21 April 2014

City of West Linn
Attn: Tom Soppe
Cc: David Emami
Re: Shady Hollow Village

NARRATIVE – Shady Hollow Village

Project Description: Construction of thirteen duplex buildings as a PUD on a 2.08 acre site with base zoning of R4.5, including conditions of approval from previous land use action that changed zoning to R4.5 from R10.

1 SITE PLAN
DRS2 1" = 20'-0"

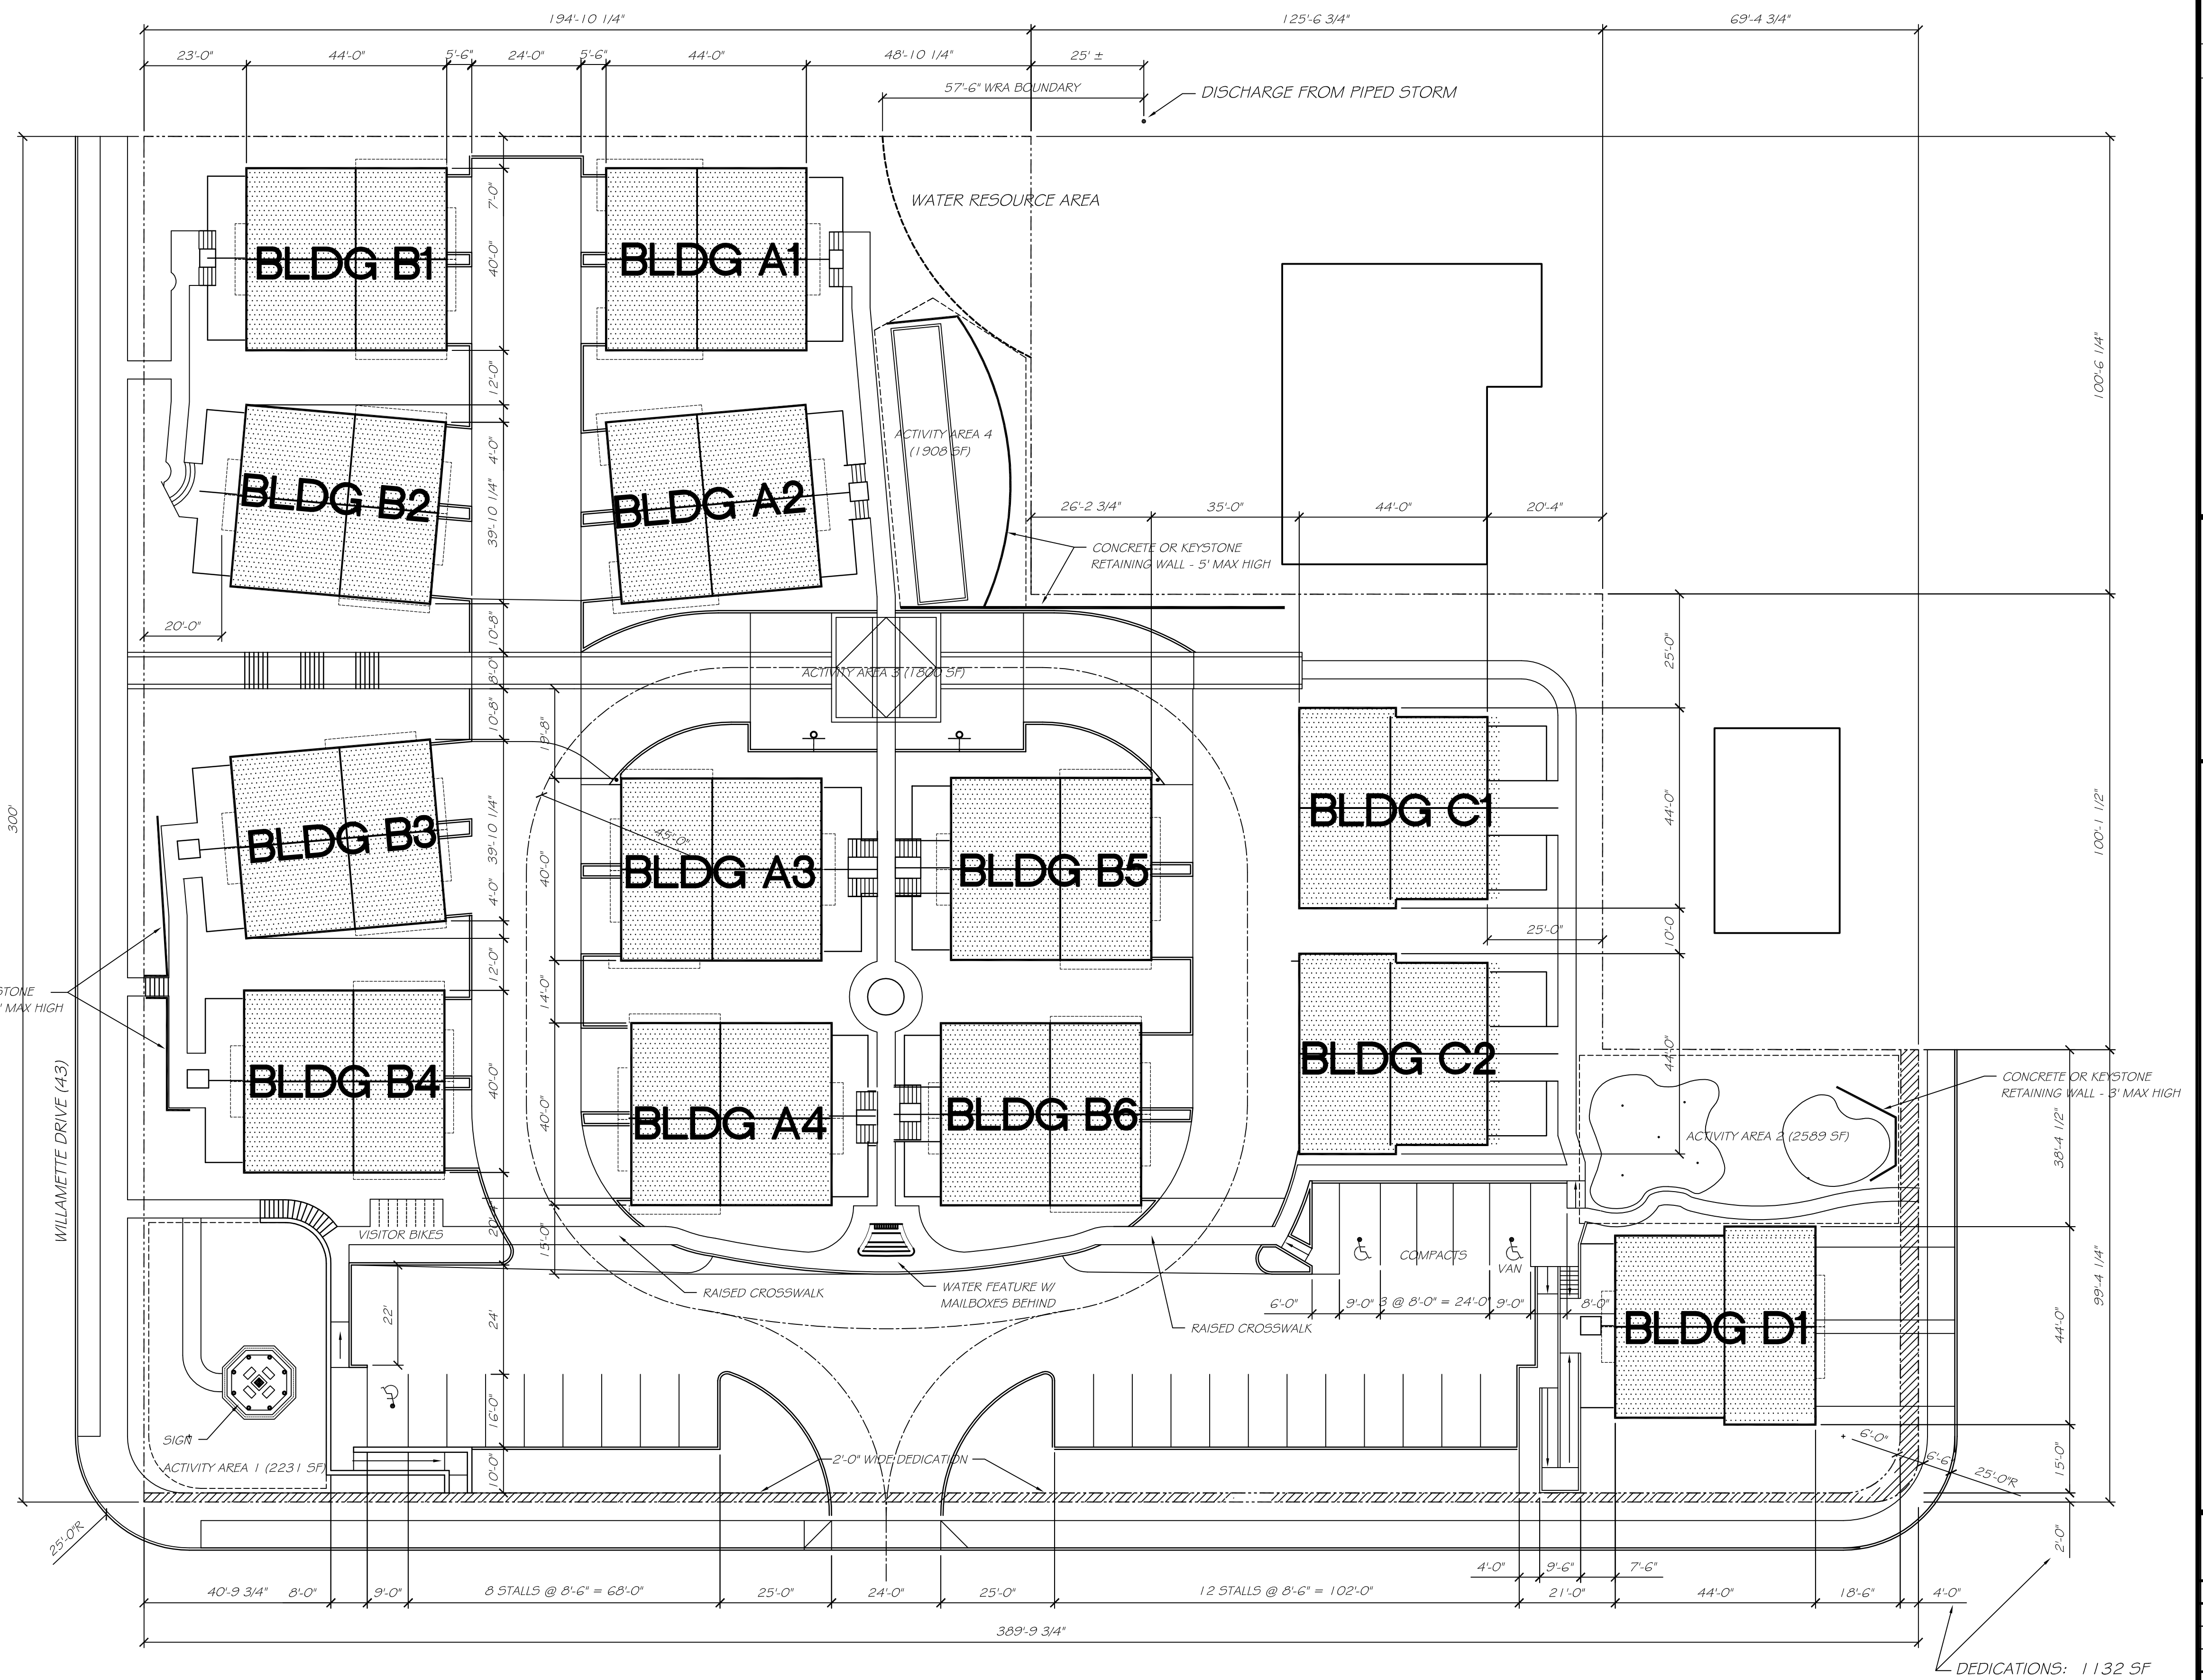
Section 32.060(A) and 55.110(A) – map added to drawing DRS2

Section 55.120(D) – graphic scale has been added to drawings DRS1 and DRS2

Section 55.120(G)(7) – a call-out for the main sign on the gazebo in activity area 1 has been added to drawing DRS2

Curb radius at intersections – radius has been modified to 25' on drawing DRS2

SHEET TITLE
**ON SITE
UTILITY PLAN**
SHEET #
DRS4

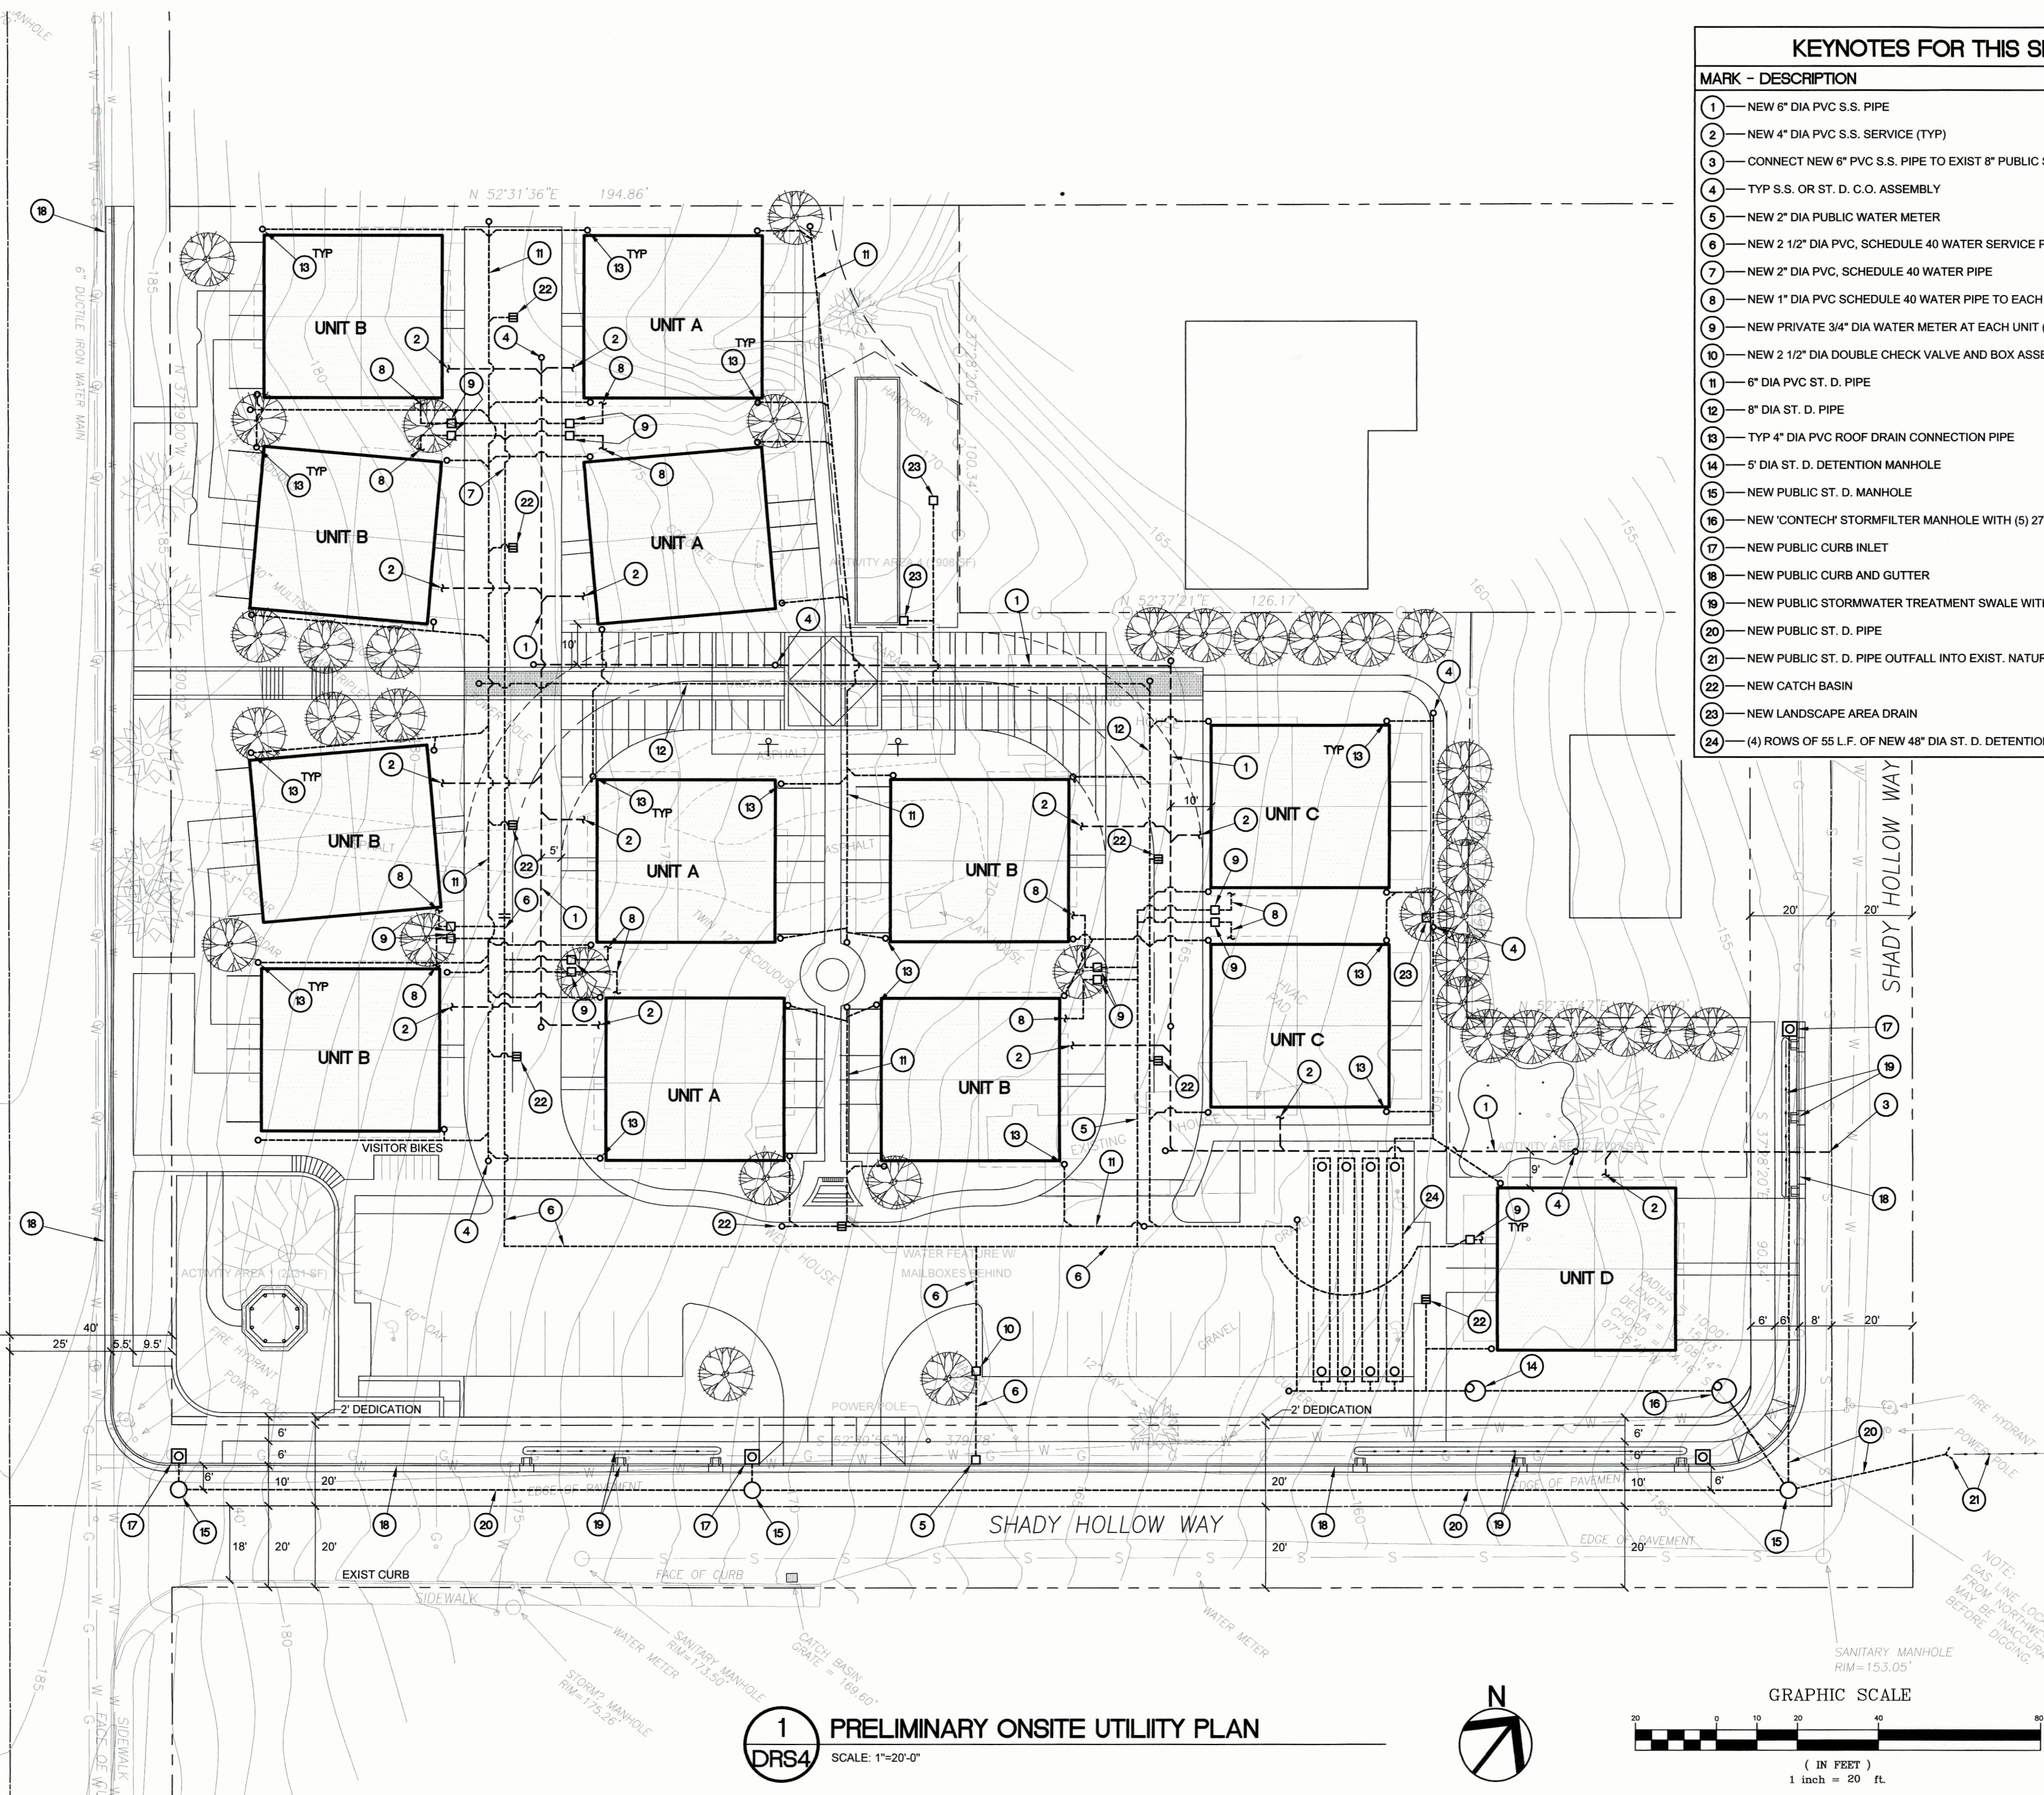
Findings: A preliminary design for storm water management is shown on drawing DRS4 based on calculations attached herewith; detention is proposed by soils report due to conditions that are not conducive to infiltration.

SHEET TITLE
PROPOSED LIGHTING PLAN
SHEET #
DRS7

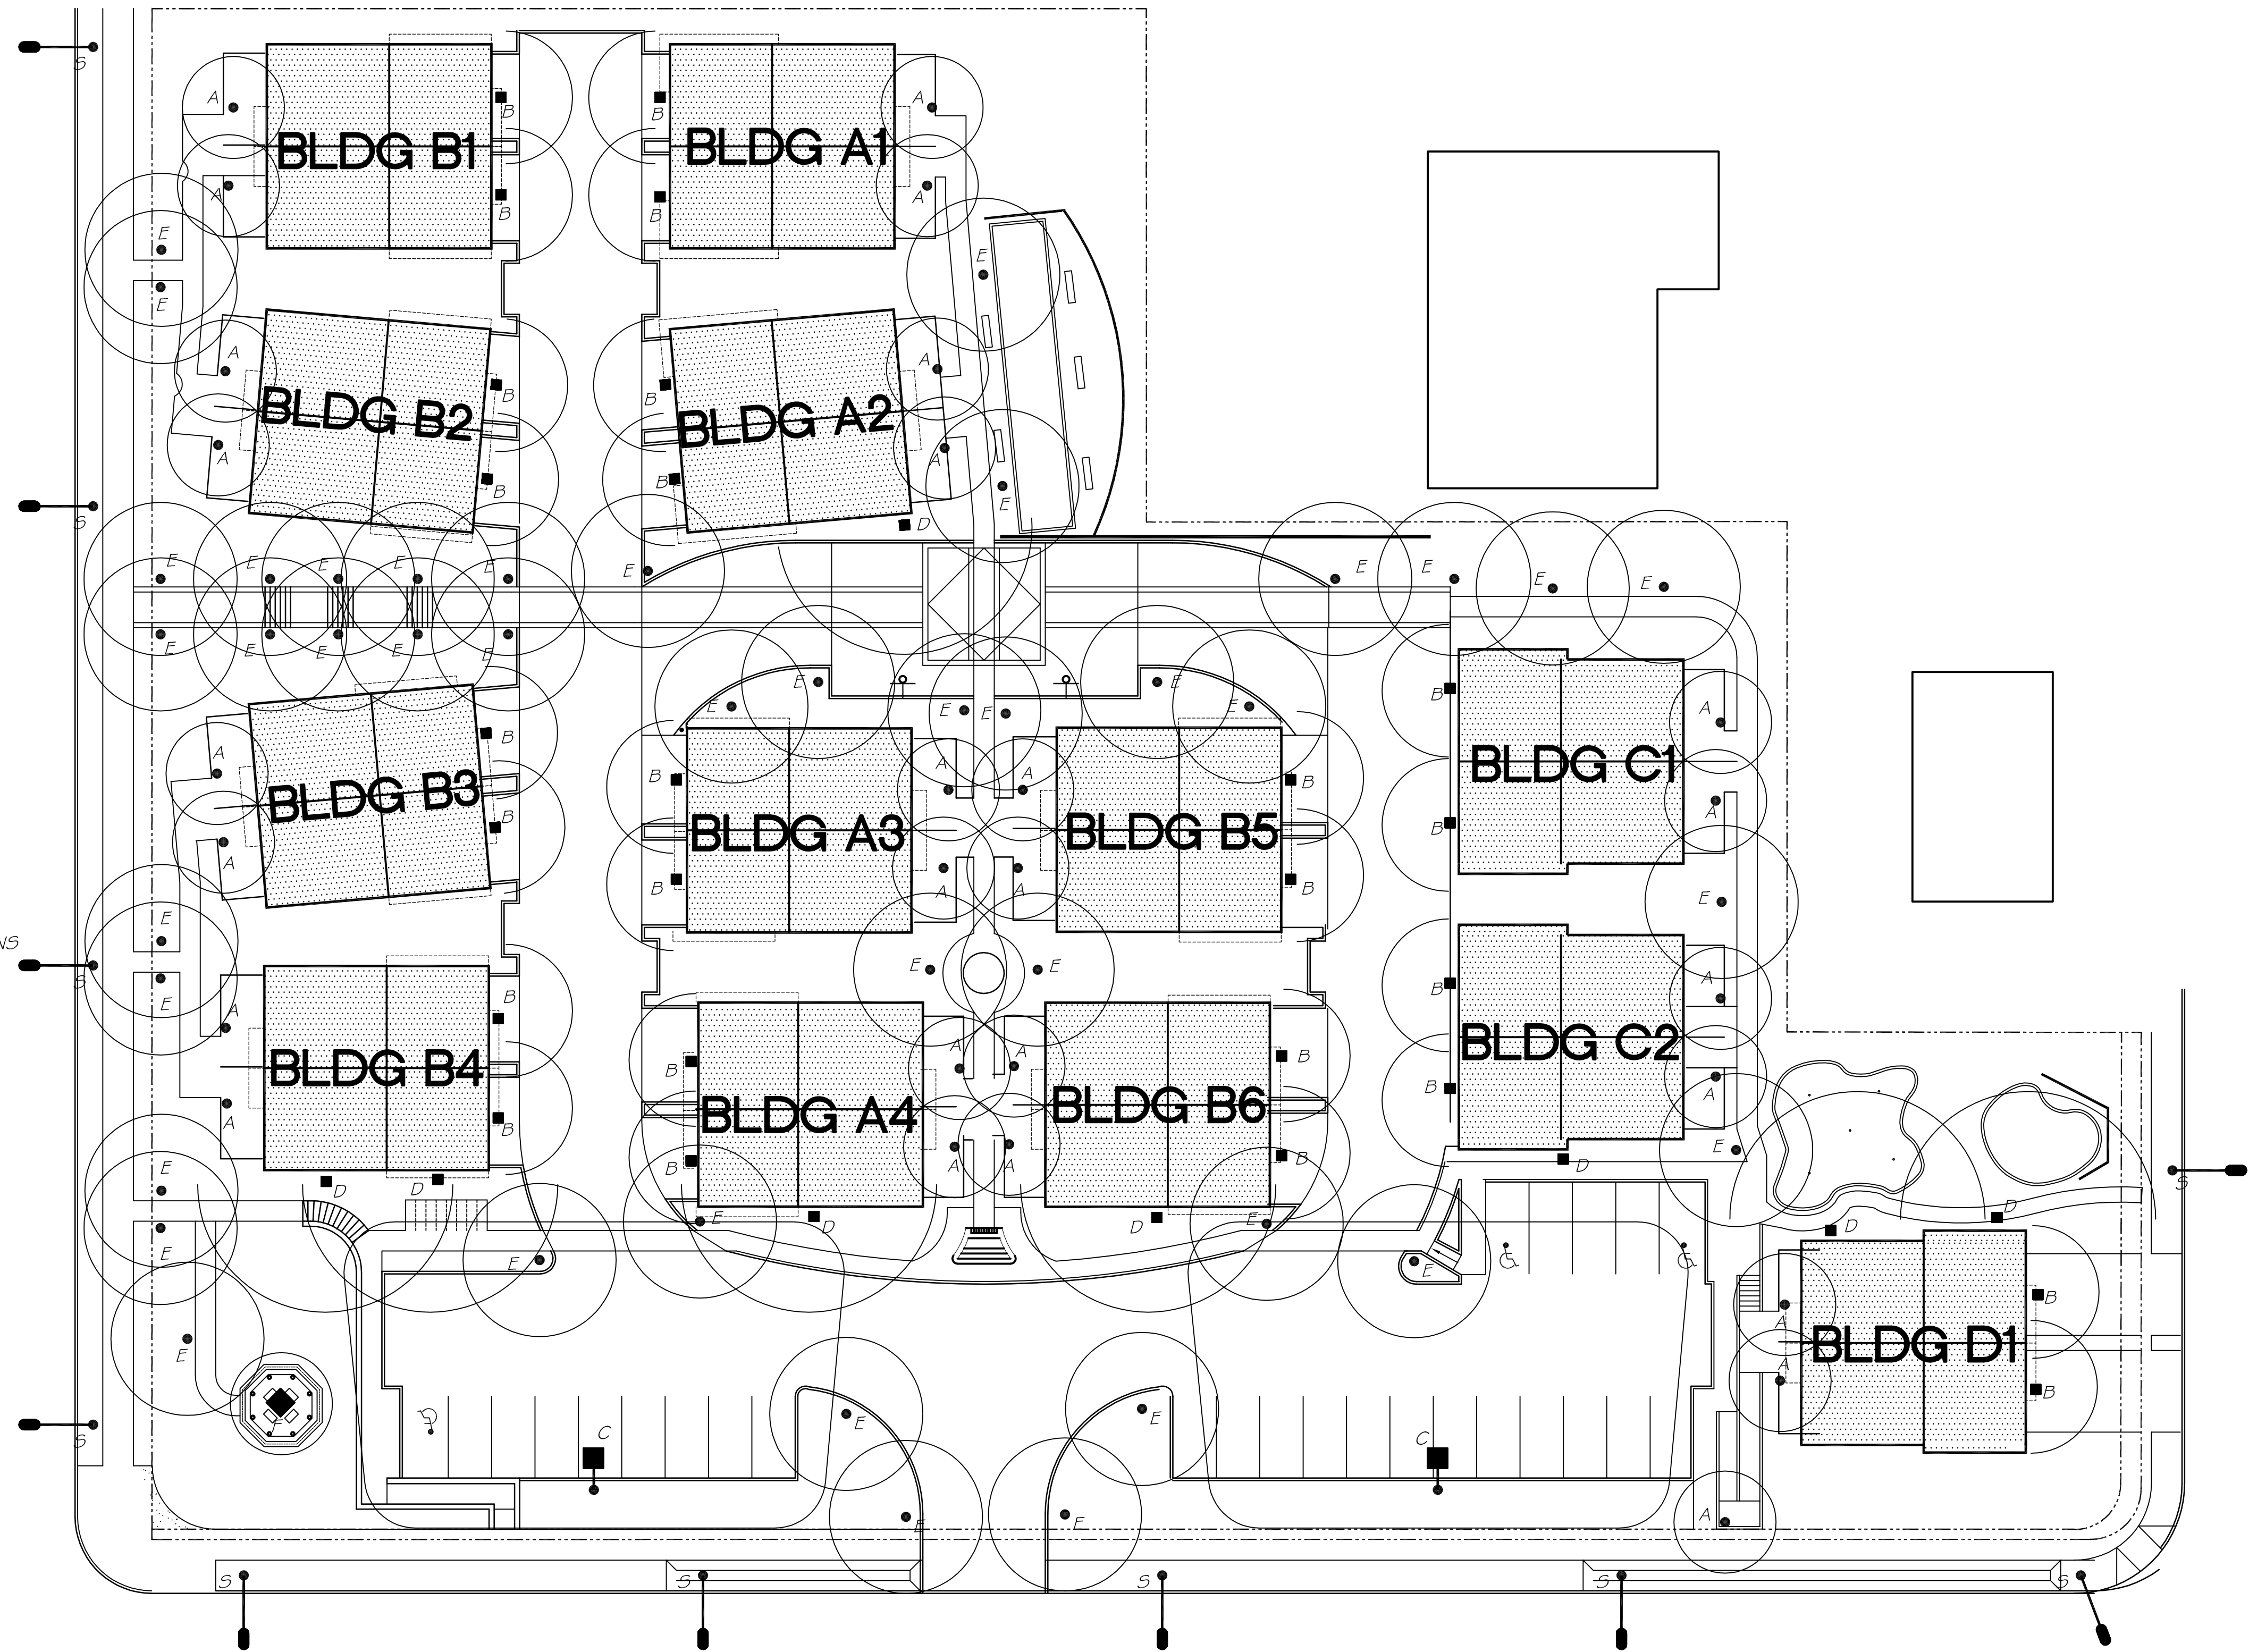
Street lighting – final design for layout and fixture selection will be done in concert with PGE, however, the lighting plan DRS7 has been modified to show general locations anticipated and also notes City of West Linn standard 150W HPS Cobra Head type fixtures.
